Subject: Revision 3 to Transnuclear, Inc. (TN) Application for Amendment 11 to the Standardized NUHOMS<sup>®</sup> System, Response to First (Restart) Request for Additional Information (Docket No. 72-1004; TAC NO. L24080)

Reference: Letter from B. Jennifer Davis (NRC) to Donis Shaw (TN), "FIRST (RESTART) REQUEST FOR ADDITIONAL INFORMATION FOR REVIEW OF AMENDMENT 11 TO THE STANDARDIZED NUHOMS<sup>®</sup> SYSTEM (TAC NO. L24080)," February 19, 2010

This submittal provides responses to the request for additional information (RAI) forwarded by the reference above. Enclosure 2 herein provides each of the NRC staff RAI followed by a TN response. Enclosure 3 provides a list of additional changes, not associated with the RAI. Enclosure 4 provides a list of Certificate of Compliance (CoC), Technical Specifications (TS), and updated final safety analysis report (UFSAR) pages associated with Revision 3. For the most part these are changed pages, but based on the RAIs, all TS pages are included, for continuity. Enclosure 6 provides the pages.

**Figure W.1-1**  
**OS197L TC Configuration**

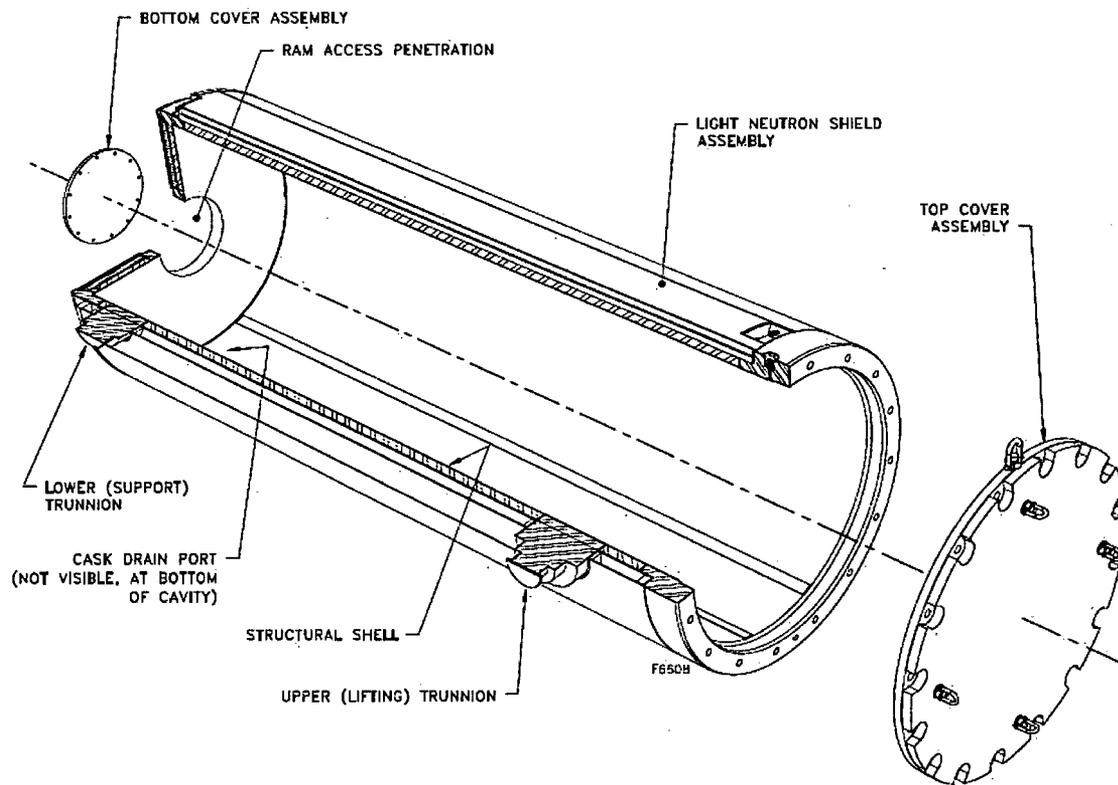
Q-14 Figure W.1-1, OS197L Configuration (page W.1-9). Is “LIGHT” or “LIQUID” the correct word in the label on the neutron shield assembly?

**Figure W.5-2**  
**Bounding Radial Dose Rate Results for the Various OS197L TC Shielding Configurations**

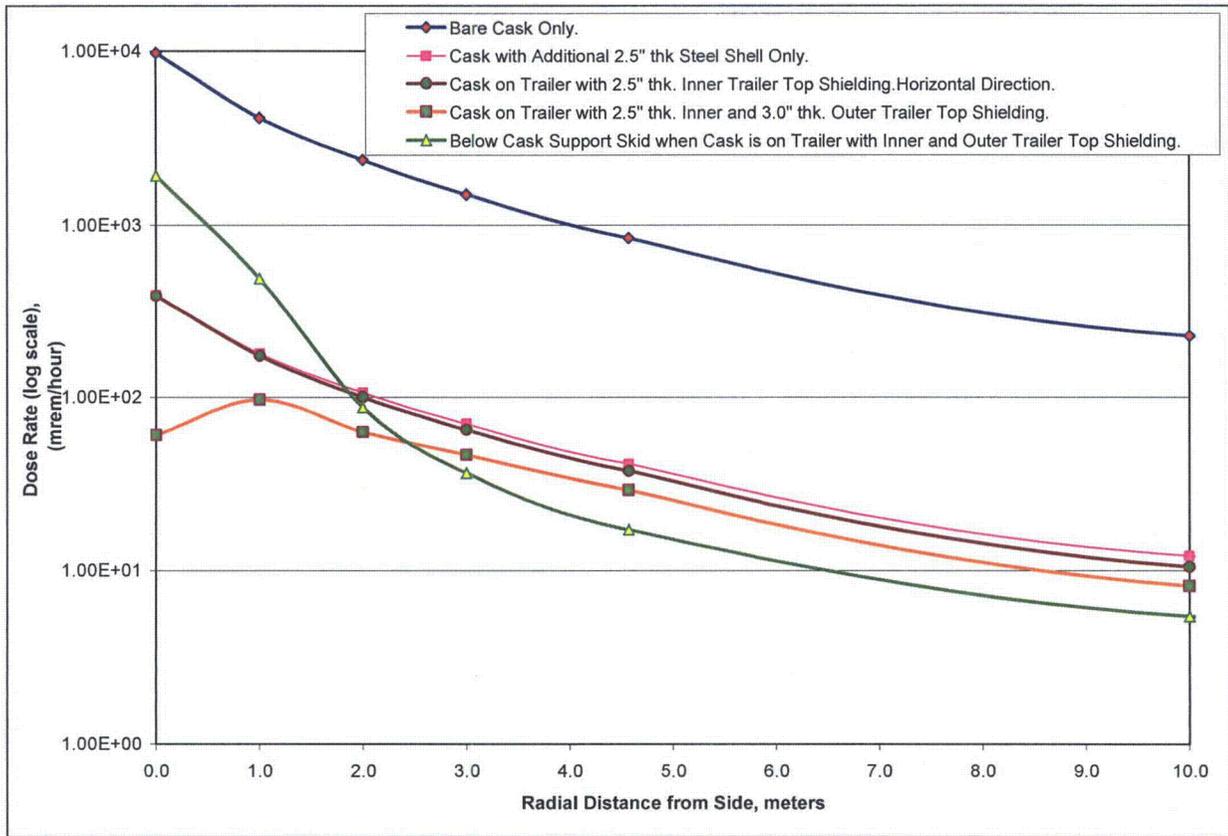
- 5-17 Section W.5.1.2, Bounding Dose Rates as a Function of Distance (pages W.5-4, W.5-38, and W.5-40). Confirm what is plotted in Figure W-5-2 and revise the text, referenced table, and figure, appropriately.

The last paragraph indicates that the plotted values in Figure W.5-2 for the case "Below Cask Support Skid when Cask is on Trailer with Inner and Outer Trailer Top Shielding" come from Table W.5-14. However, Table W.5-14 indicates that its data represents the configuration "Prior to Installation of Outer Top Trailer Area Shielding."

In roughly the middle of the paragraph Figures W.5-1 and W.5-2 are cited as showing the quarter symmetry of the MCNP model. It does not appear that Figure W.5-2 is the correct figure to reference here. In the last sentence of the second paragraph, an incorrect figure appears to be referenced. Figure W.5-1 shows the shielding configuration. Figure W.5-2 has plots of dose rates and appears to be the correct figure to cite here.

*Section W.5.1.2 is modified and includes description of the dose rates plotted in Figure W.5-2. The plot for the case "Below Cask Support Skid when Cask is on Trailer with Inner and Outer Trailer Top Shielding" shown in Figure W.5-2 is based on dose rates calculated at an elevation below the cask support skid. The dose rate distribution at this elevation is not significantly dependent on the outer top trailer shielding. Therefore, the dose rates shown in Table W.5-14 are applicable.*

*A total of four different shielding configurations are evaluated although five different plots are shown in Figure W.5-2. For one of the shielding configurations, dose rates are calculated at two different locations. Section W.5.1.2 is revised to provide a clear description of these configurations and the dose rate results. Please see the response to RAI 5-17.*

**Figure W.5-5**  
**Description of the Trailer Area Shielding Calculational Model**

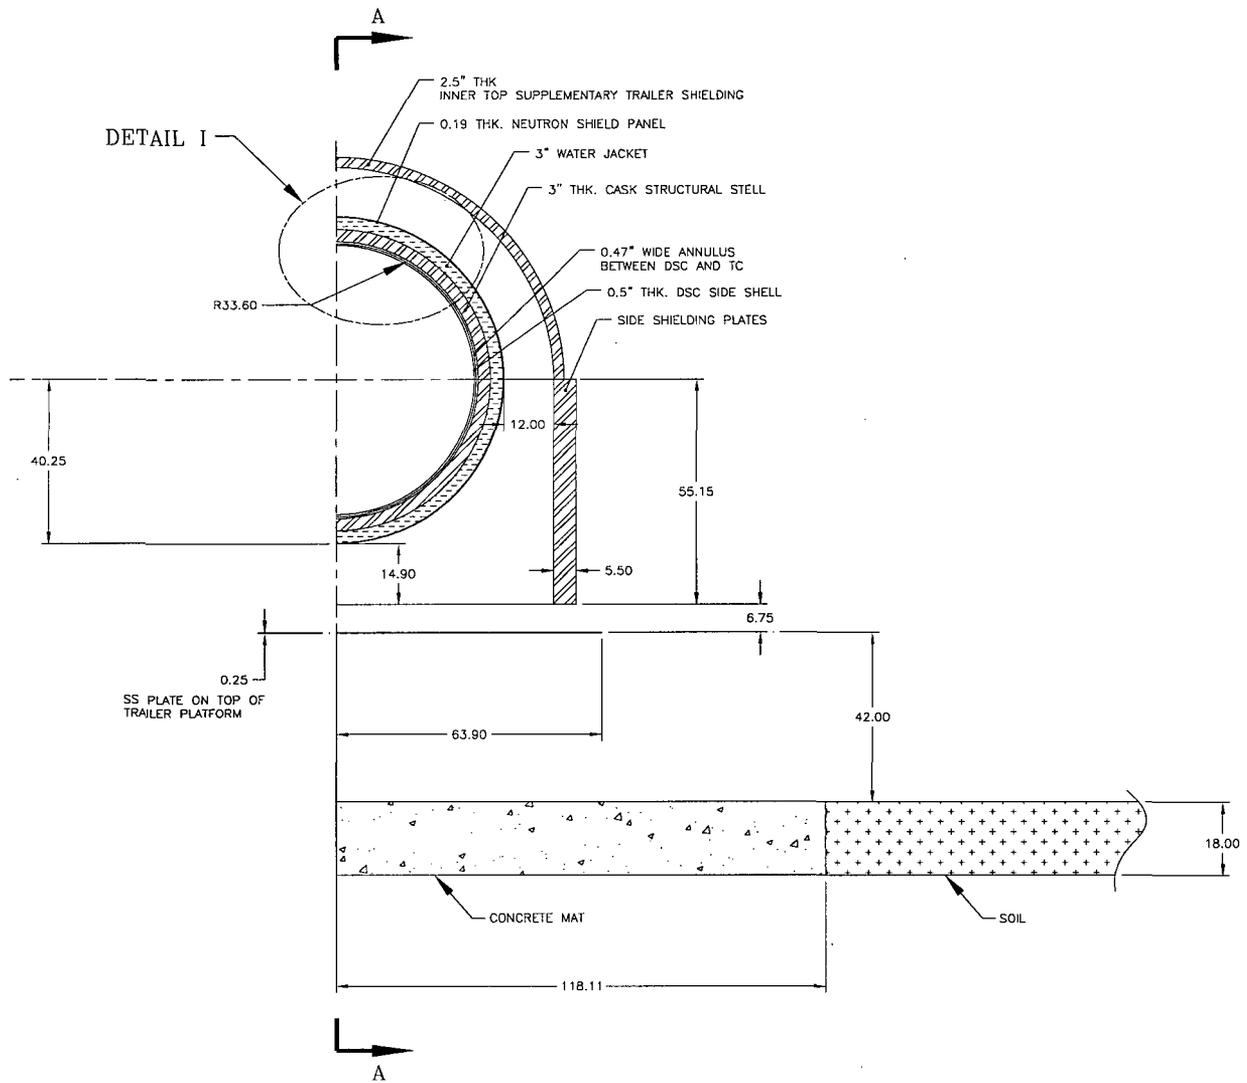
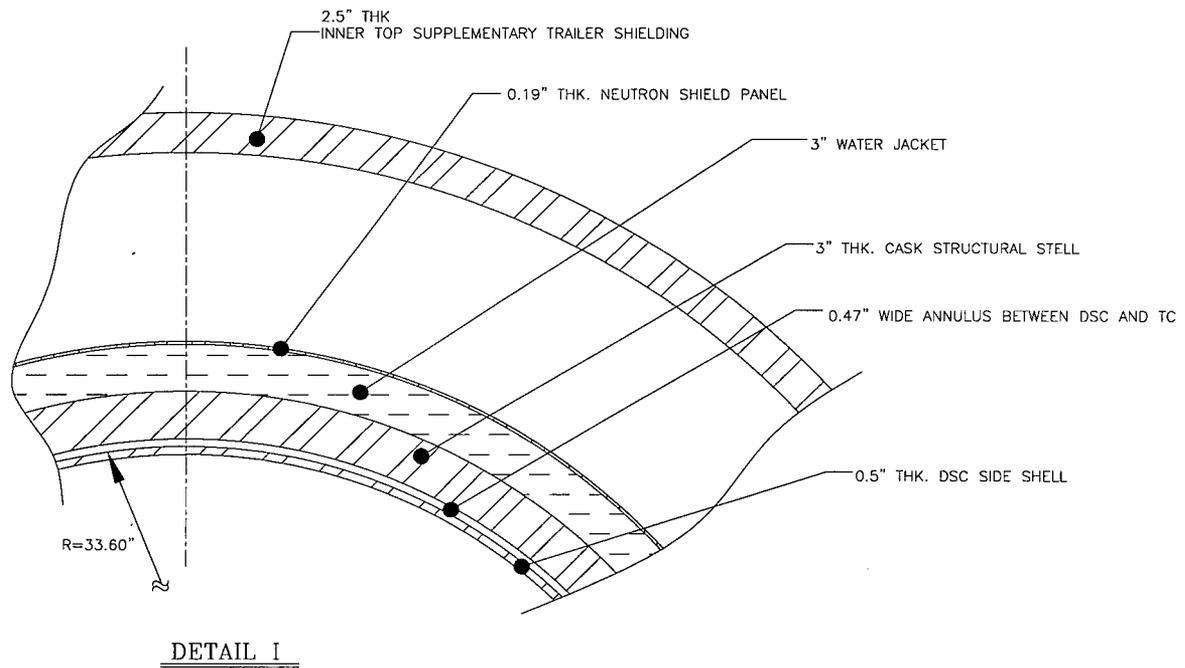
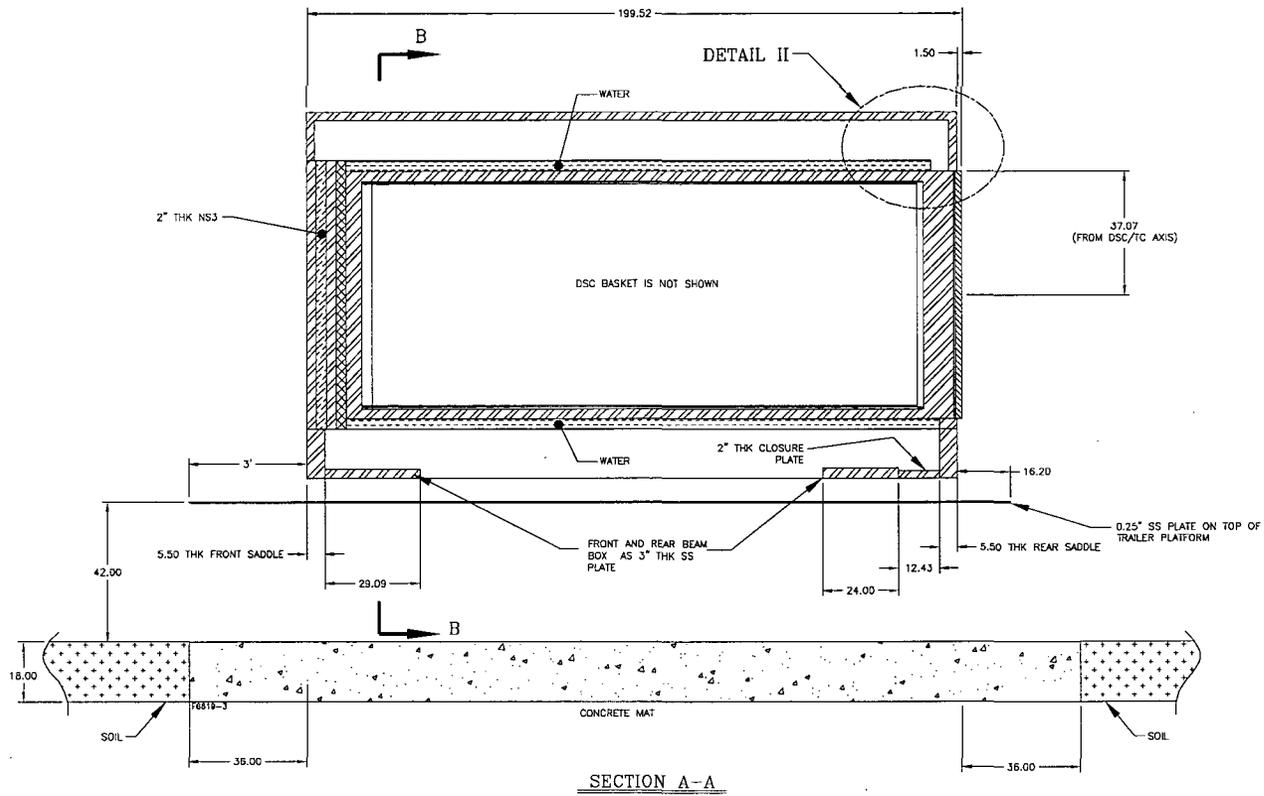
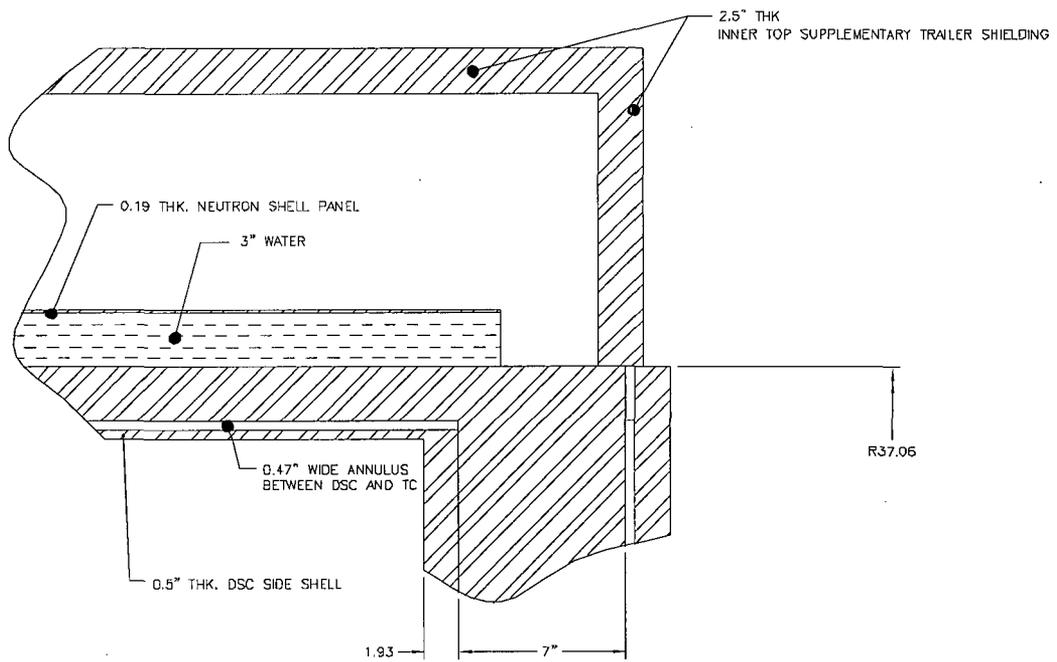
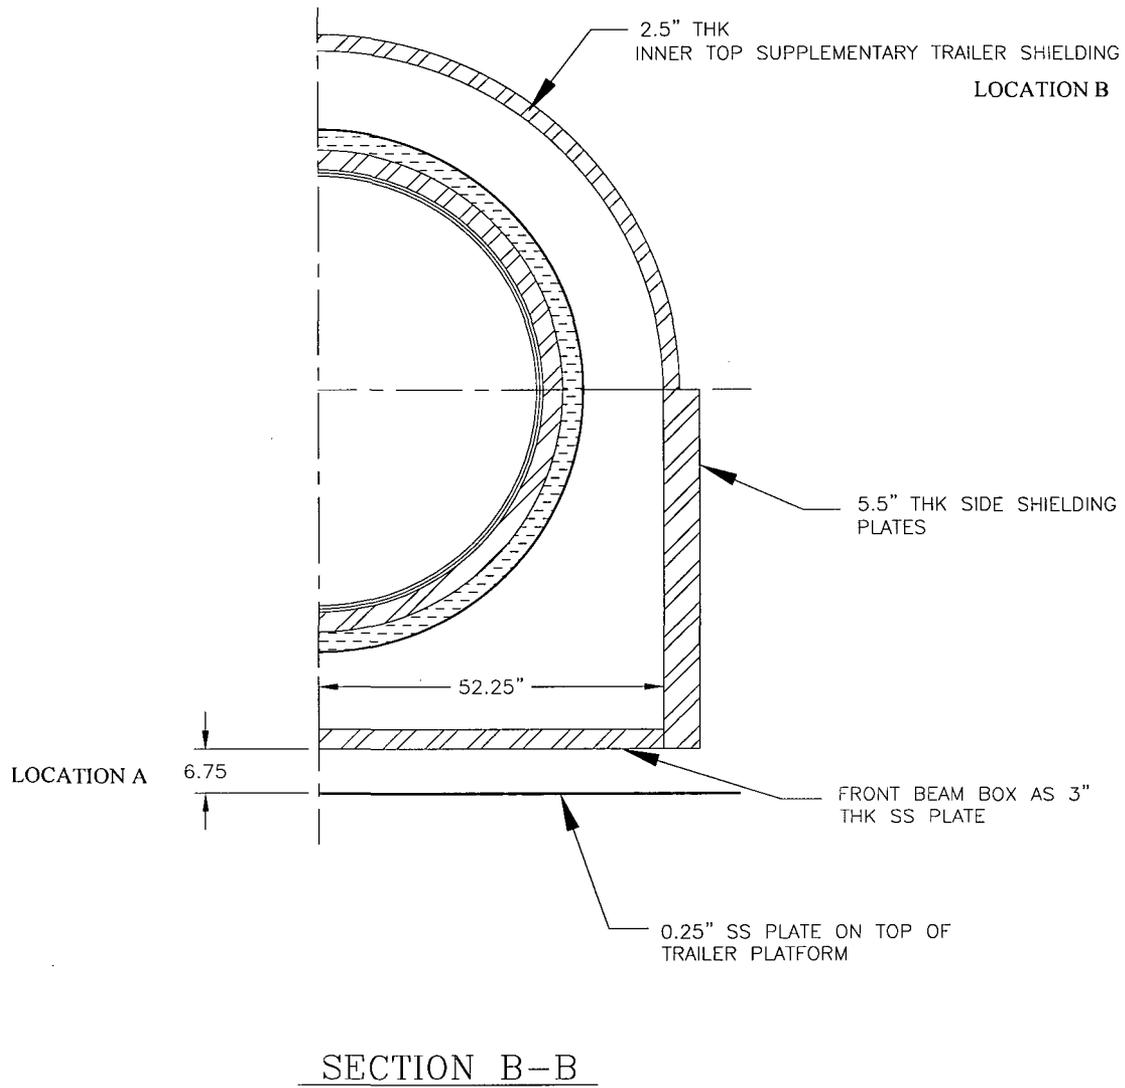
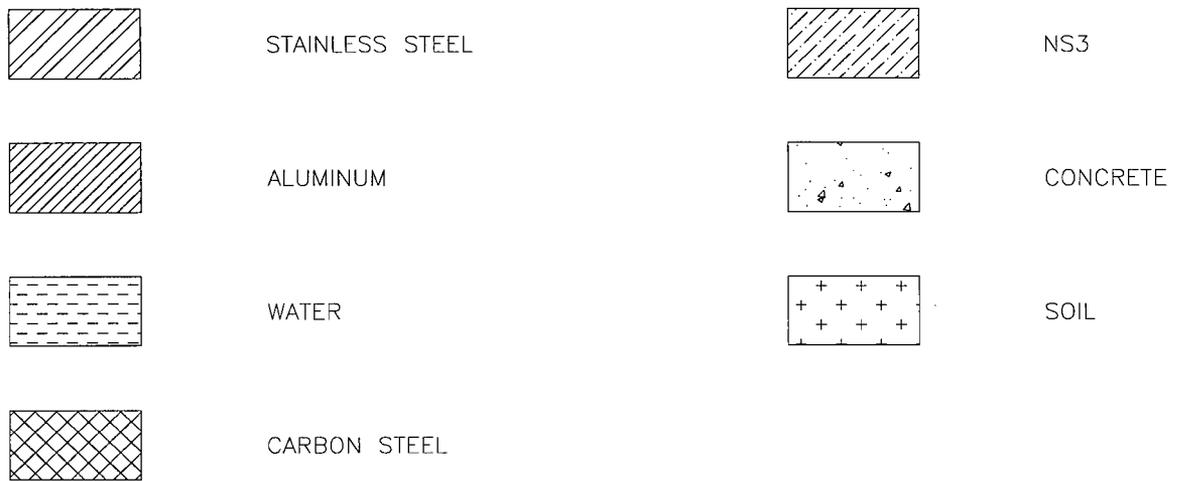
- Q-28 Section W.5.4.10.4, TC Placement in the Transfer Trailer (page W.5-24). The first paragraph of this section cites Figure W.5-7. There is no such figure in Section W.5. Correct this here and anywhere else it occurs.

Q-33 Table W.5-13, OS197L Radial Dose Rates with... (page W.5-37). The note following this table refers to Figure W.5-7. This figure is not included in the document. Correct this note by either including the figure, or citing the correct figure. (See also RAI 5-24.)

*UFSAR Section W.5.4.7 is revised to provide a clearer description of the modeled configuration. The text describing the "bottom of the cask" is revised to indicate that the calculational model did not consider any shielding beneath the cask in the horizontal orientation on the transfer trailer except for the 0.25" plate representing the trailer platform. The reference to the "filling" of the neutron shield is modified to indicate a water-filled neutron shield. This paragraph is also revised to reference the multi-part Figure W.5-5.*

*Chapter W.5 is revised to ensure that the cross-reference information is accurate and appropriate. Specifically Section W.5.4.10.4 is revised to cite Figure W.5-5.*

*The correct figure is the multi-part Figure W.5-5. The note in Table W.5-13 is revised to indicate the correct figure.*
